ADDENDUM NO. 5
POTTAWATTAMIE COUNTY, IOWA
COURTHOUSE – Chiller Improvements
Council Bluffs, Iowa

HGM PROJECT # 107419D

DATE OF ISSUE: November 8, 2019

SD3

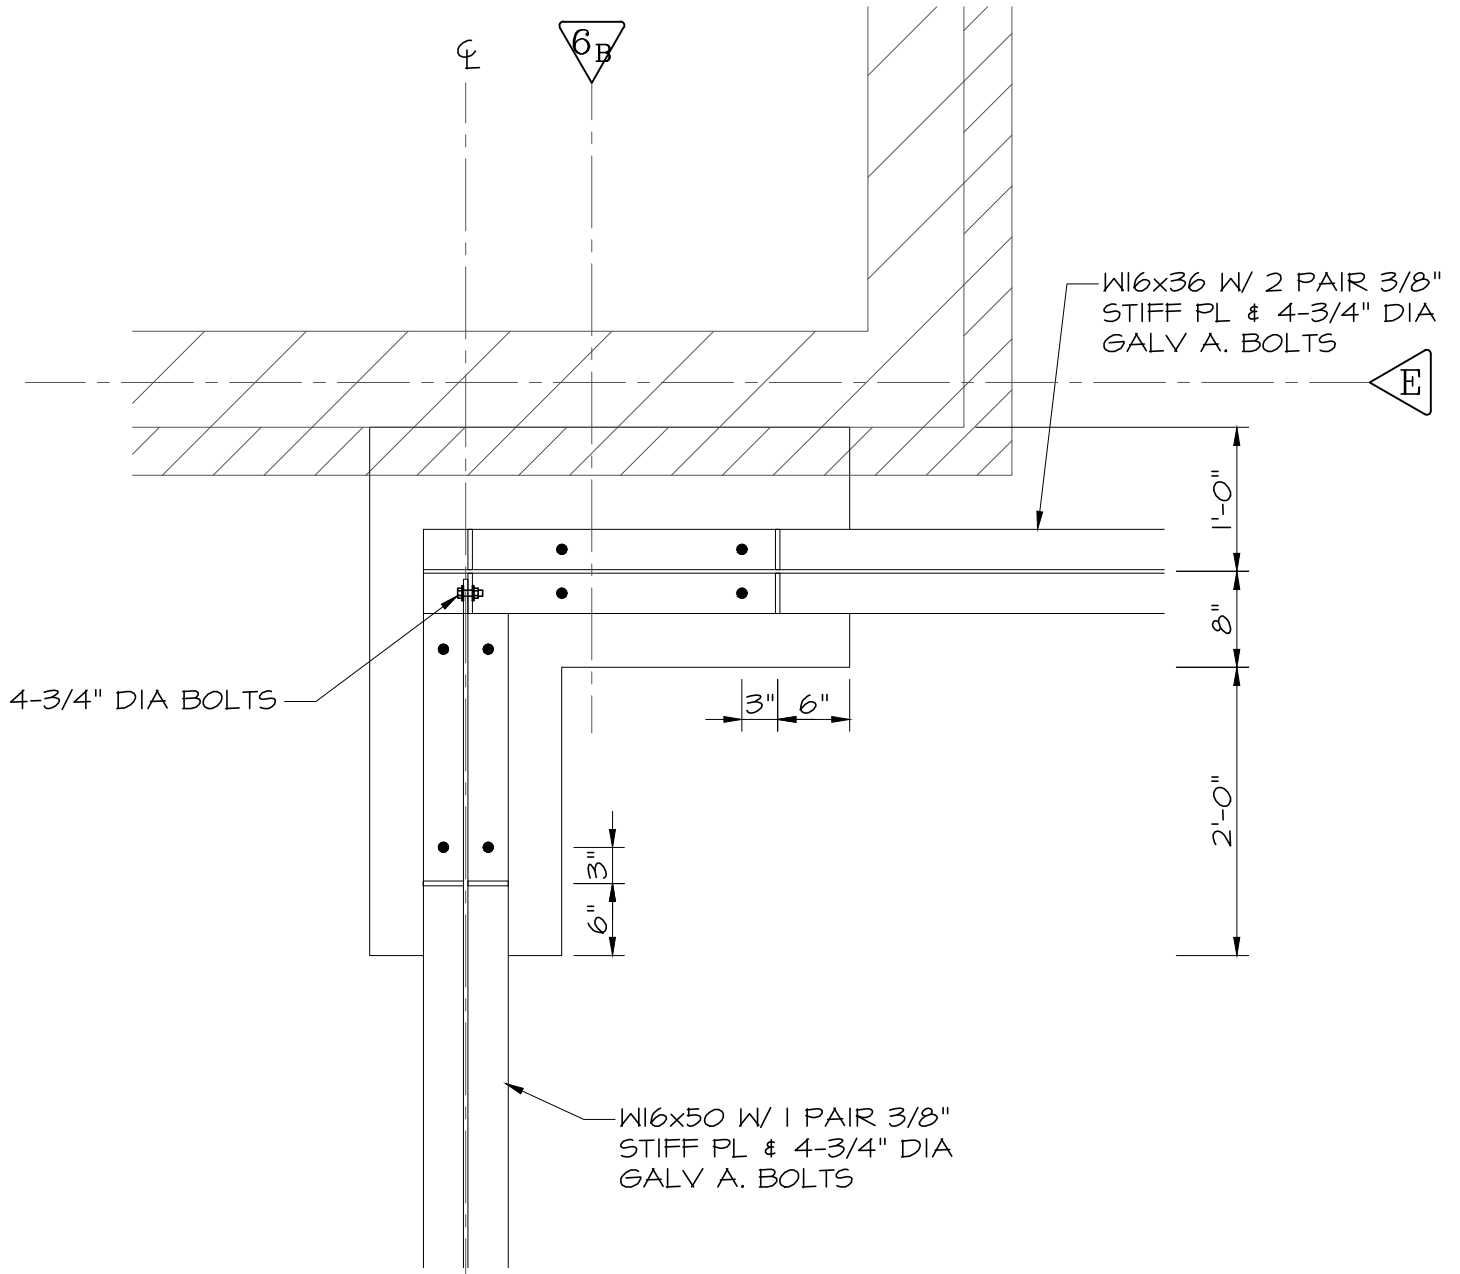
Delete Details 5, 10, and 19 in their entirety, and substitute the following attached Supplemental Drawings: SD3, SD4, SD5, SD6, SD7, SD8, SD9, SD10, SD11, SD12, SD13, SD14, SD15, SD16, SD17, SD18, SD19, SD20.

SD22

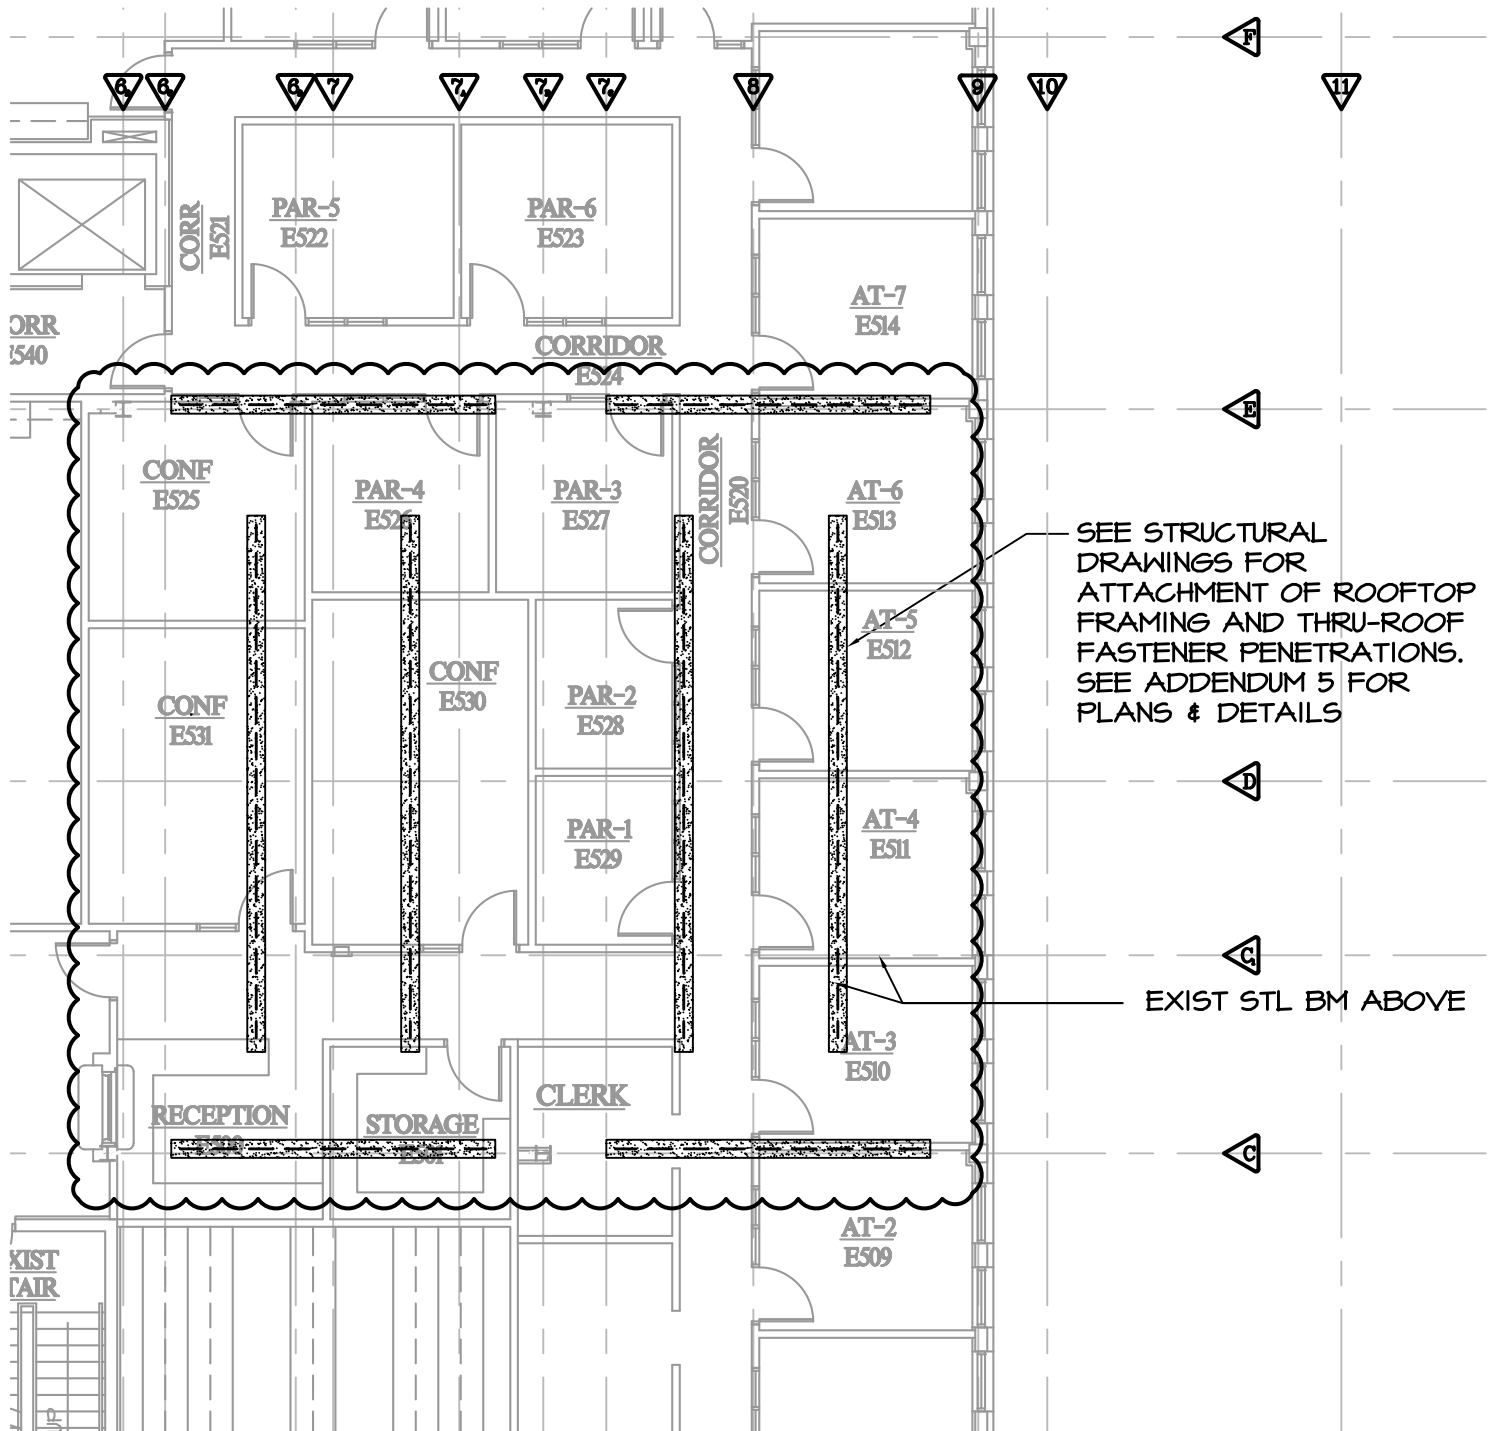
New Fire Proofing at new steel removed from project. See attachments SD22 and SD 23.

SD24

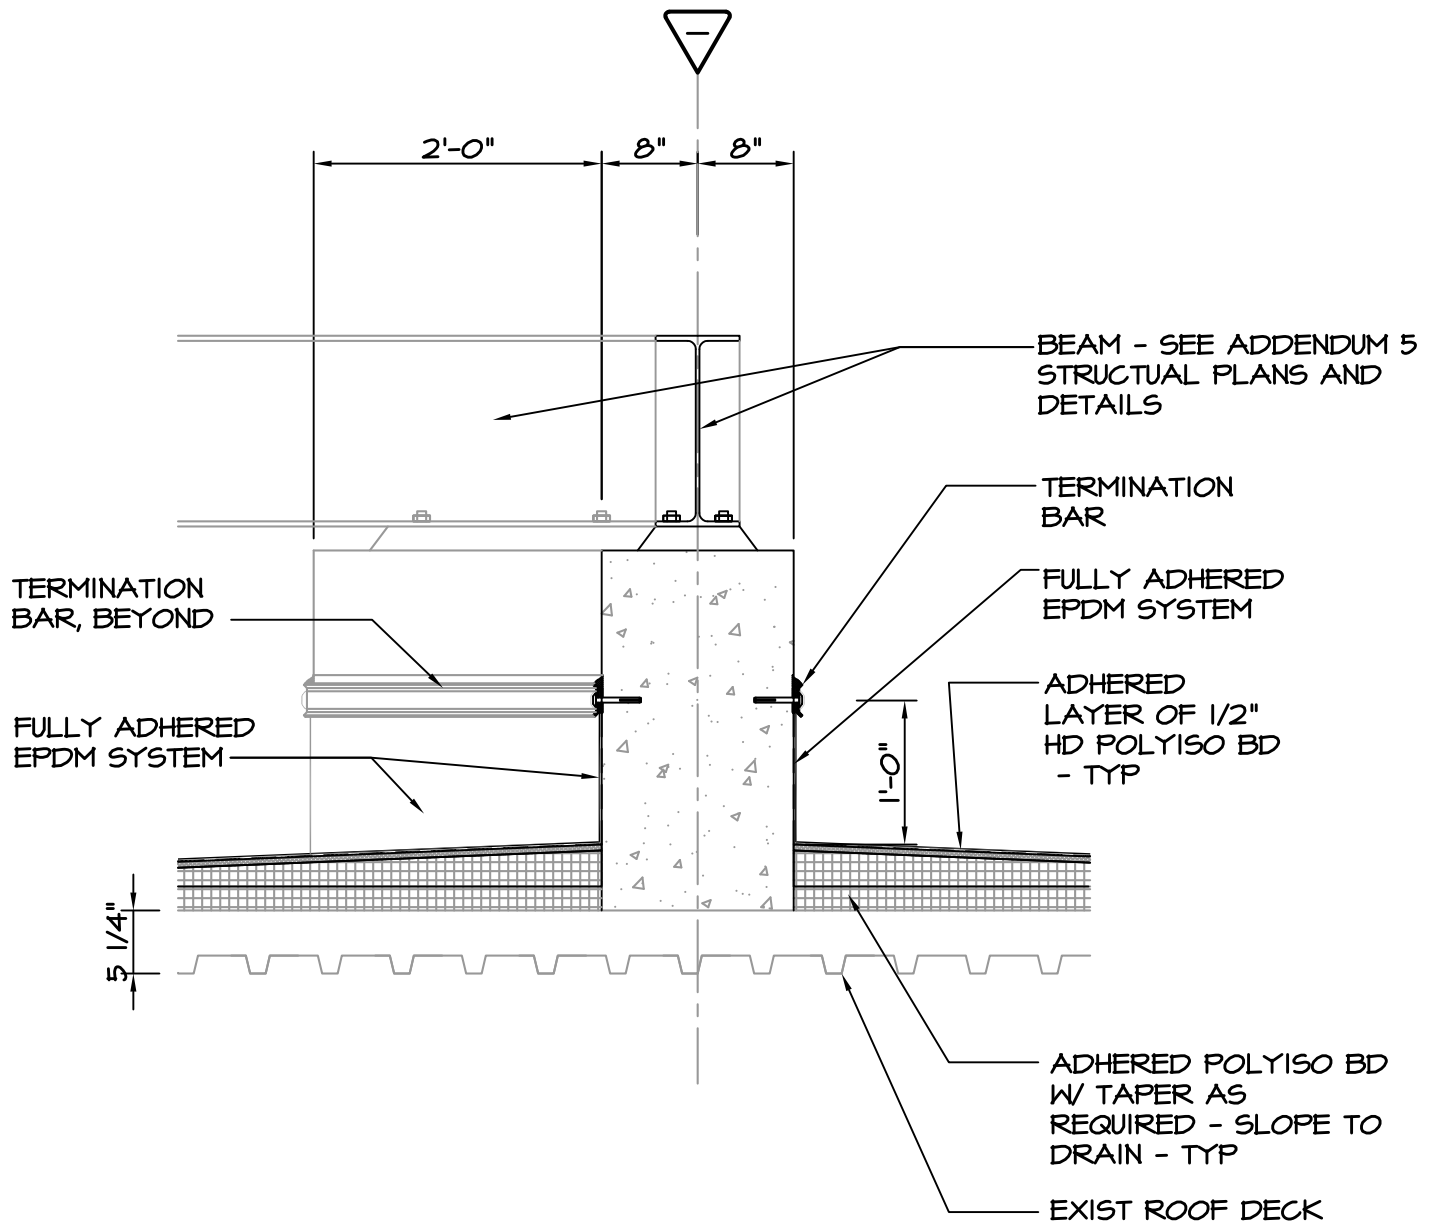
Flashing Details added at new mechanical unit structural framing supports. See attachments SD24 and SD25.

E1

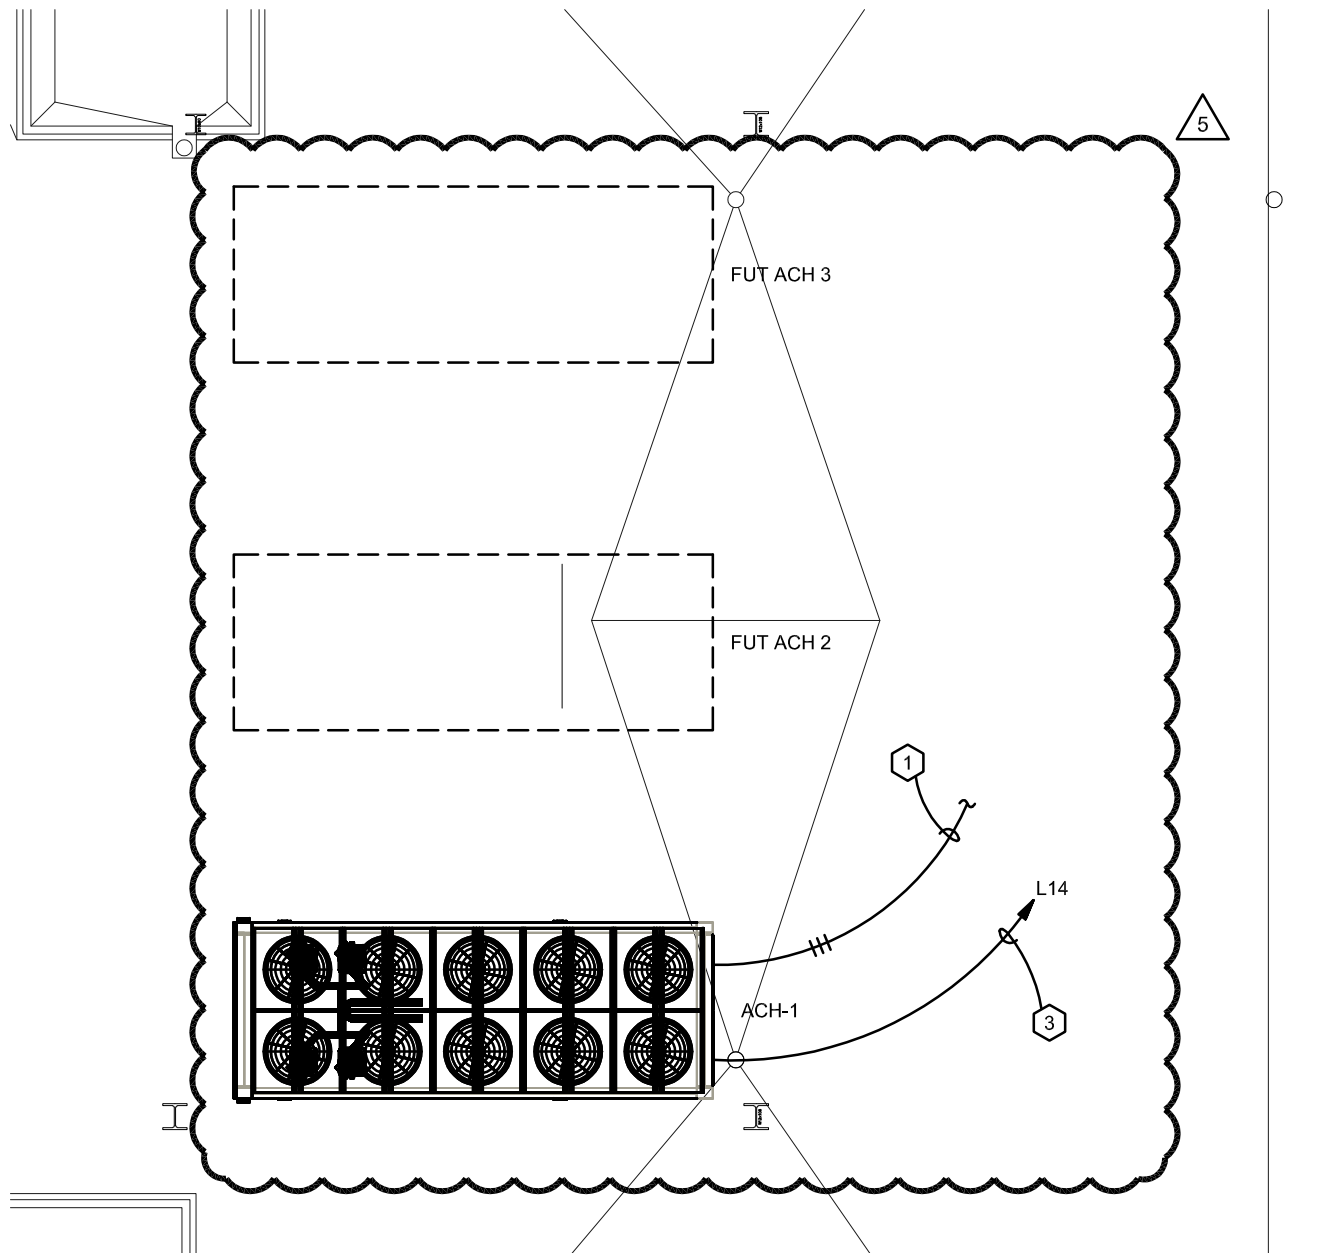
Coordinate electrical connections with new chiller locations. Refer to sketch E1.
